Otari-Wilton's Bush Trail Review

May 2020

Prepared for Wellington City Council by Kennett Brothers Ltd.

To conduct a review of the trails at Otari-Wilton's Bush and develop a preliminary concept plan for staged potential trail improvements.

Image: WCC map used online, in pamphlets and on mapboards in the reserve

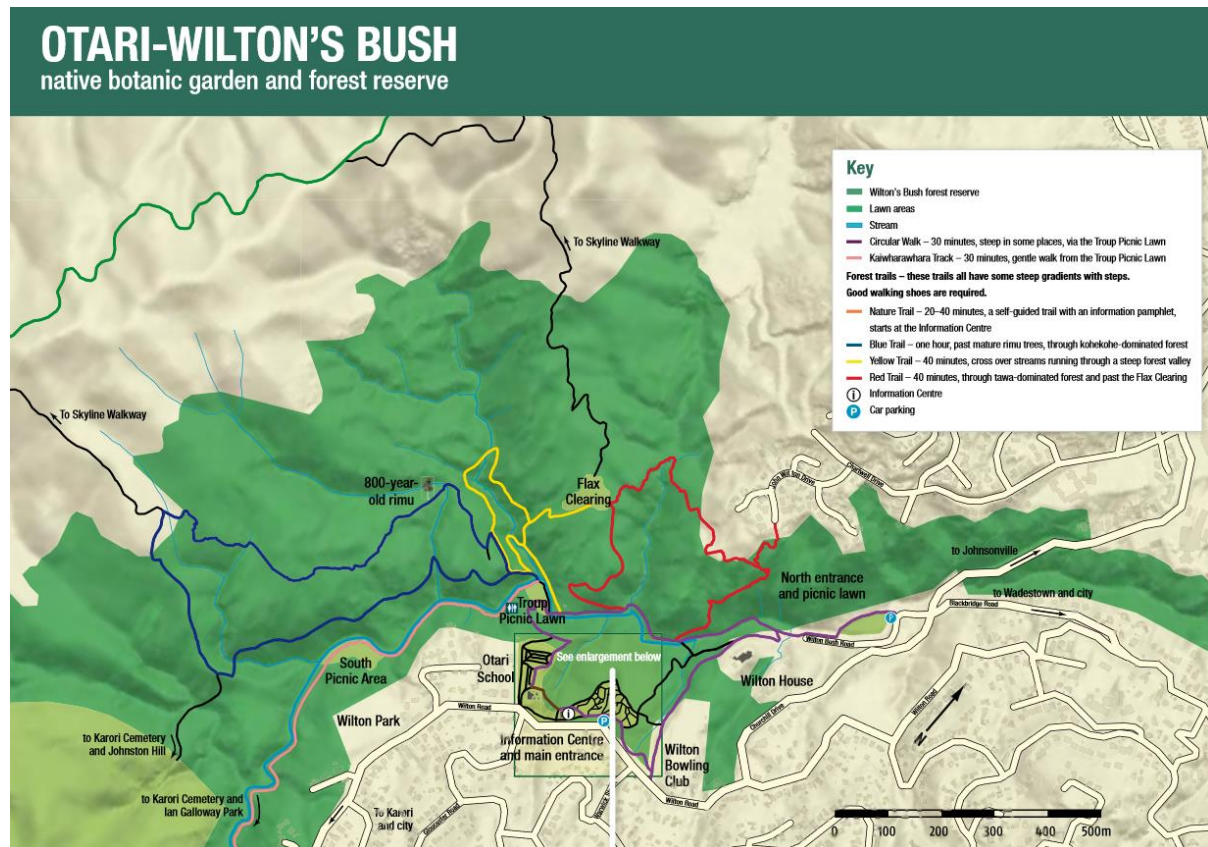
Users would benefit by having the map extent increased by a few hundred metres to show how Otari connects to the Skyline Track, Ian Galloway Park and Karori via the cemetery.

Photo 2: Entrance path

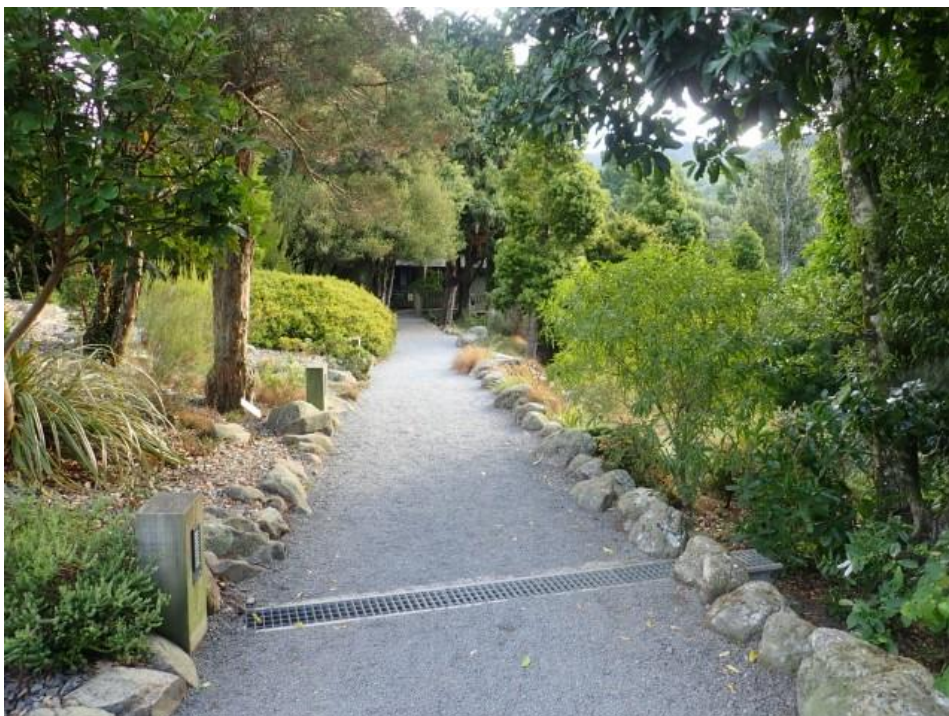
Comment: All the main paths in the botanic gardens are of this high quality.

Photo 12: Path down to lookout

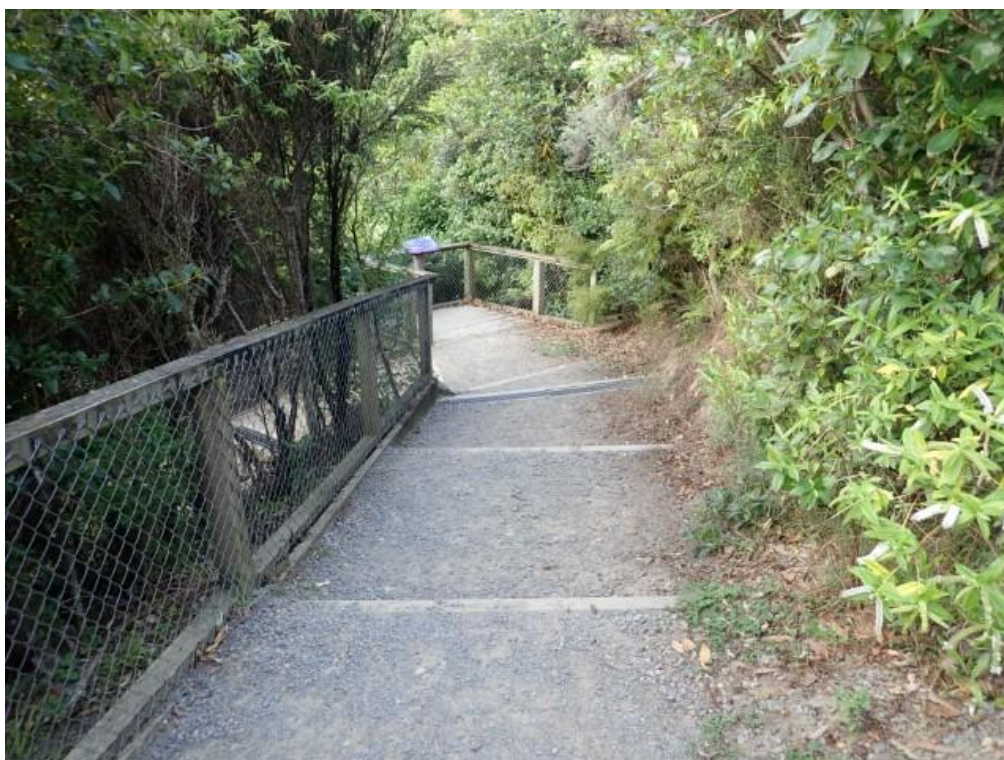
Comment: Poor handrail (is more a barrier to fall rather than a handrail) and slippery surface.

Image 1: The heatmap indicates user patterns at Otari-Wilton's Bush. The most popular track appears to be along the Kaiwharawhara valley, with far less use on side tracks.

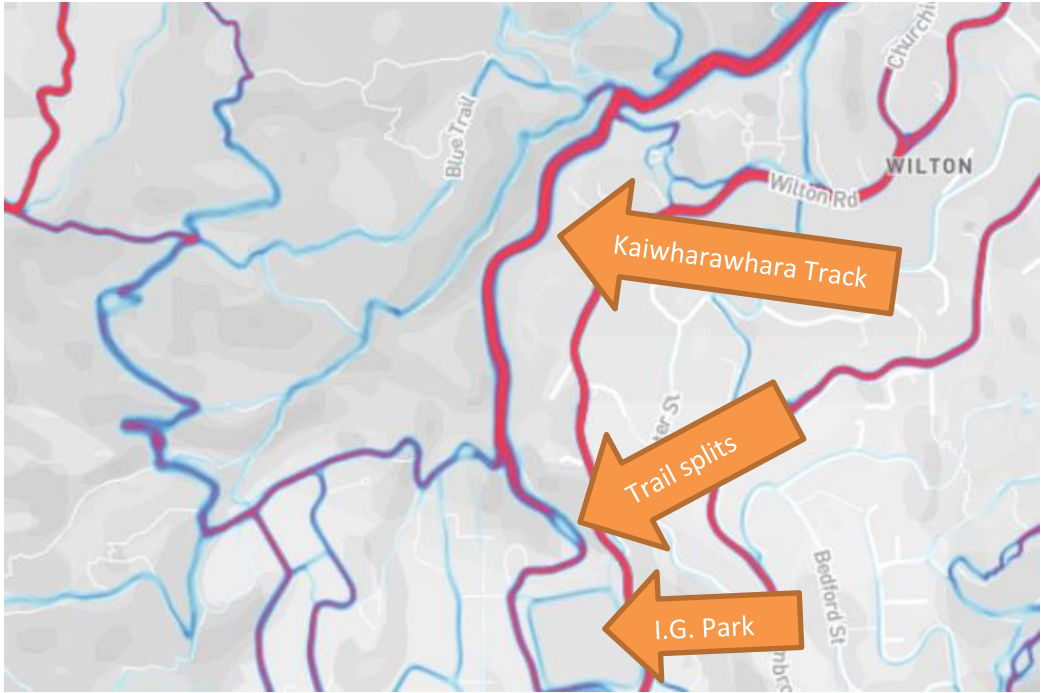
You can see use splitting where the track up to Ian Galloway Park splits in two. This report recommends upgrading the eastern option.

Photo 44: 9 steps

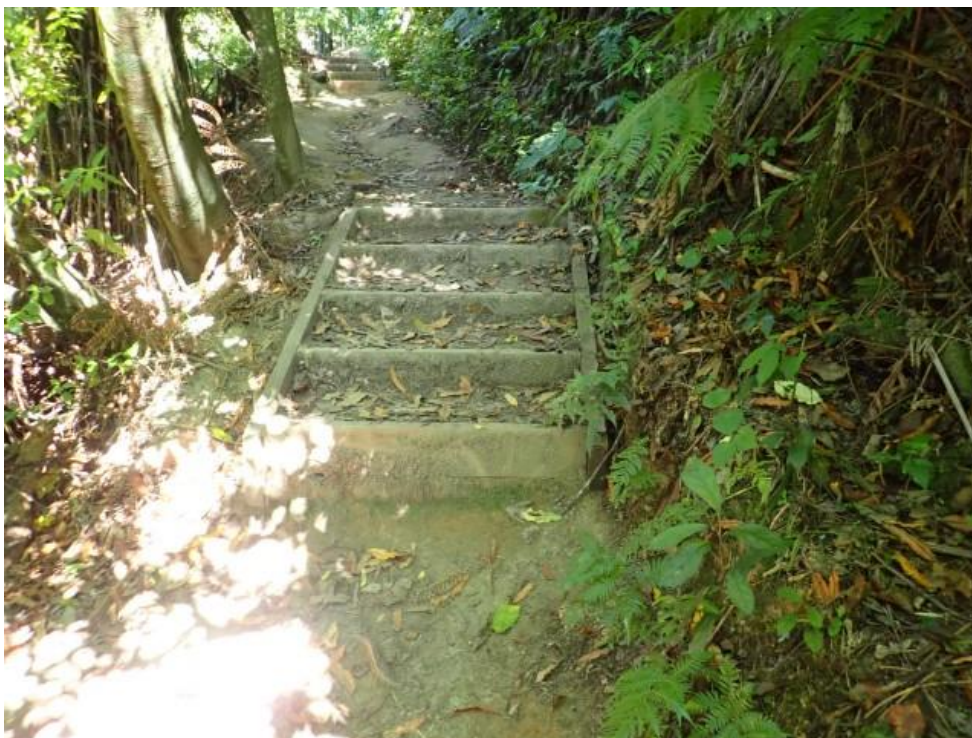
Comment: As is often the case, due to soil compaction/erosion, the bottom step riser has become too big.

Photo 27: Steep flight of steps

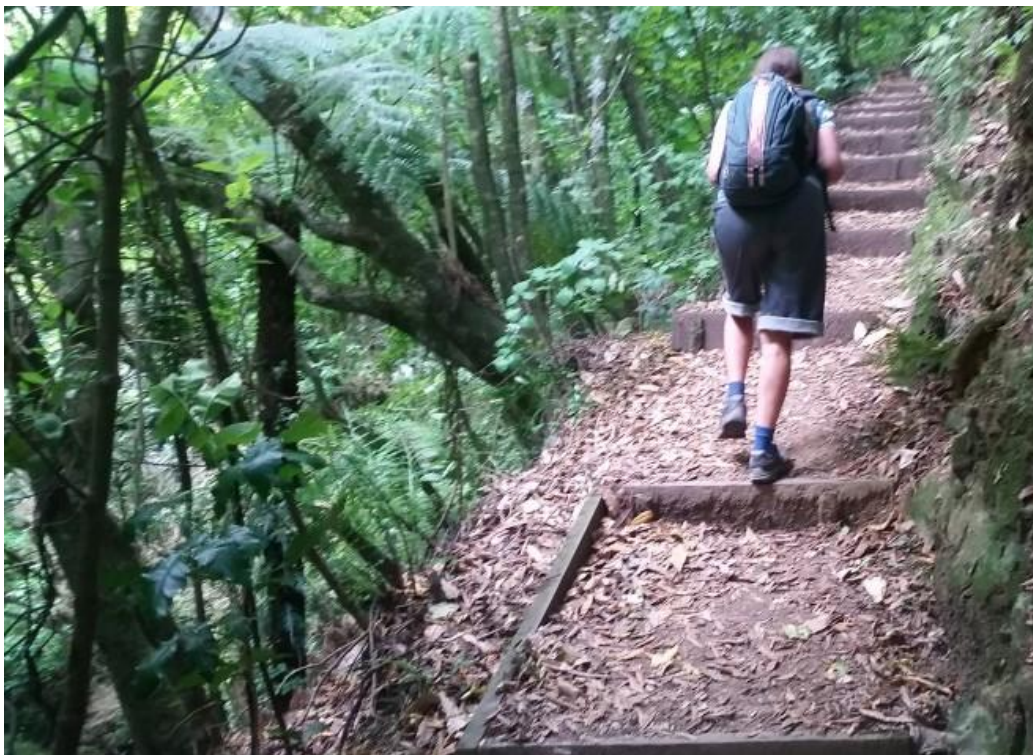
Comment: There are 48 steps, with some up to 360mm high, from the lower loop fork to the Flax Clearing fork. These steps are unavoidable in this steep terrain.

Photo 51: Steep and rooty as the track climbs up from the side stream

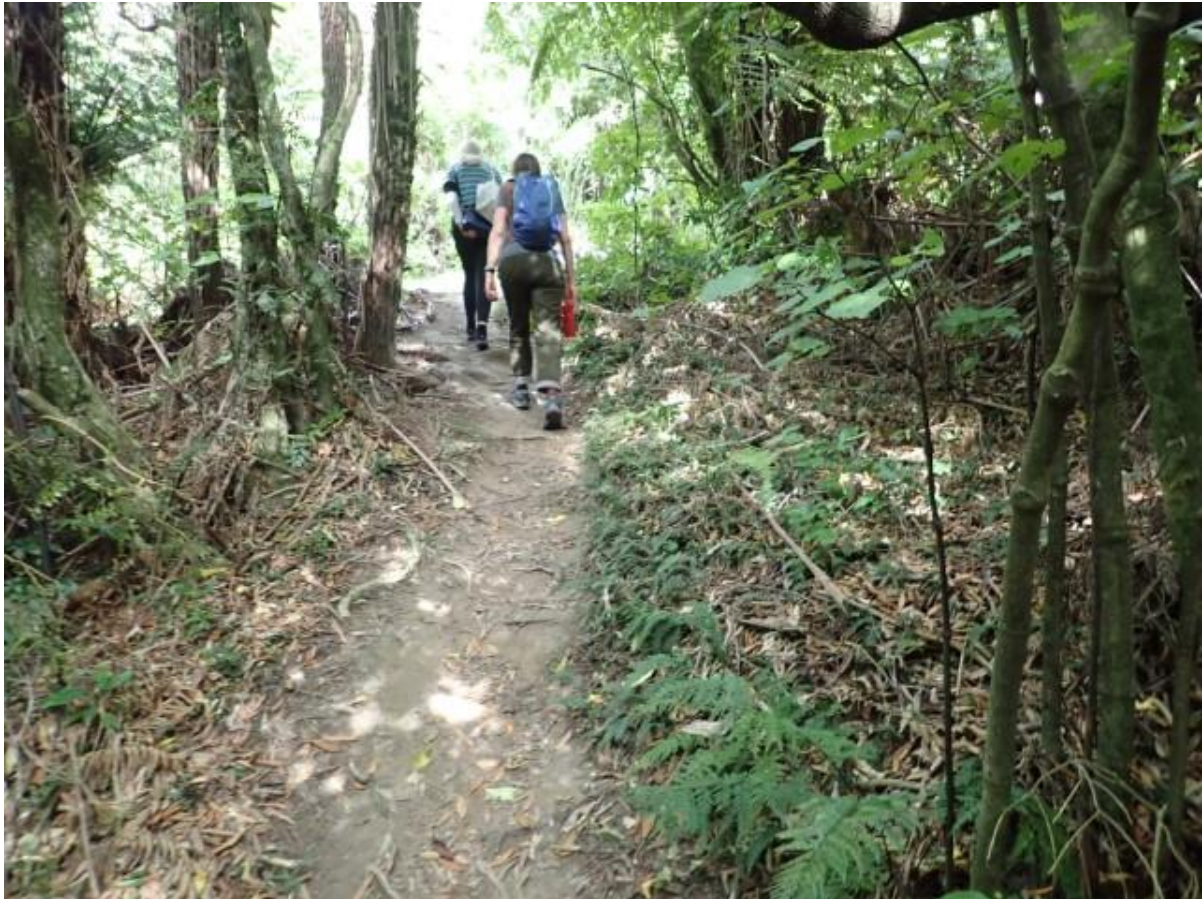
Comment: Could sidle around the dip into and out of side stream.

Photo 2: Narrow section where the track is collapsing into the stream

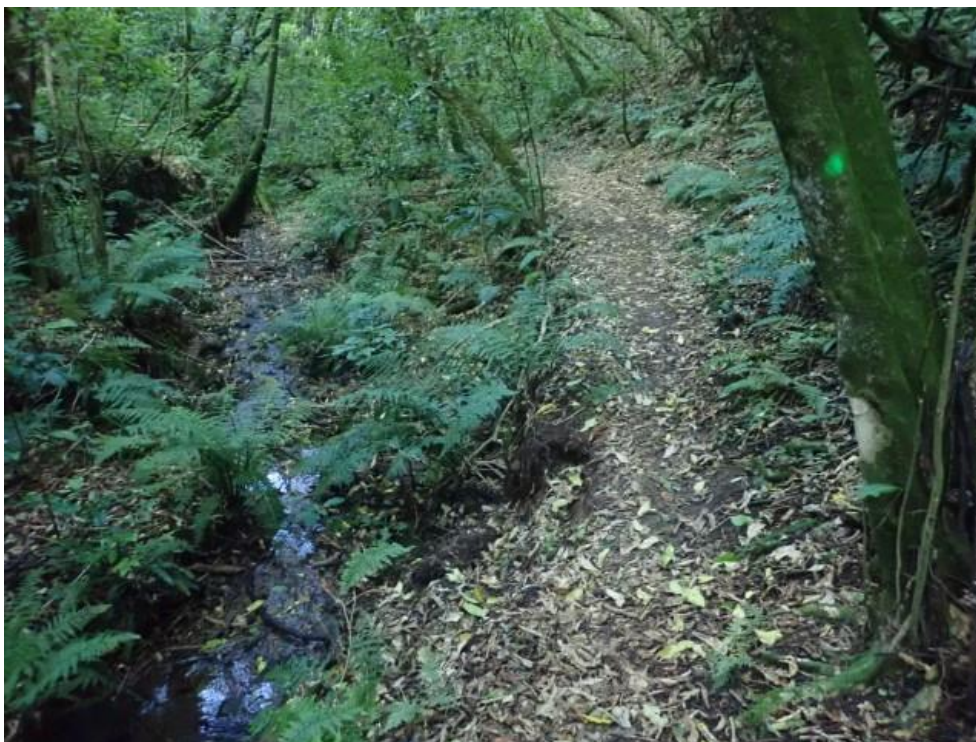
Comment: The track is now only 400mm wide.

Photo 10: Junction with the track from Karori Cemetery road down to Kaiwharawhara Track

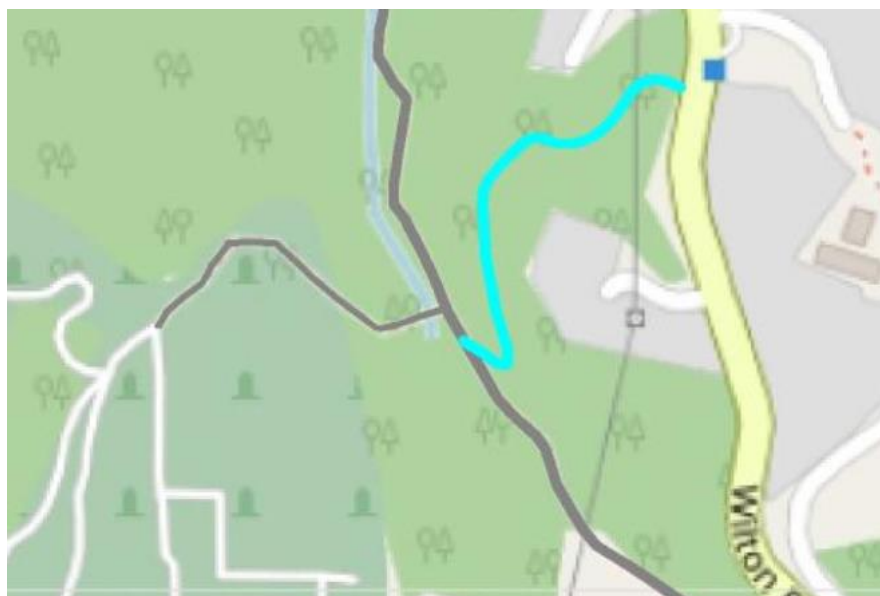
Comment: It would be good to have a clear sign on the bollard pointing up to Karori Cemetery road and down to Otari-Wilton's Bush and the Kaiwharawhara Track.
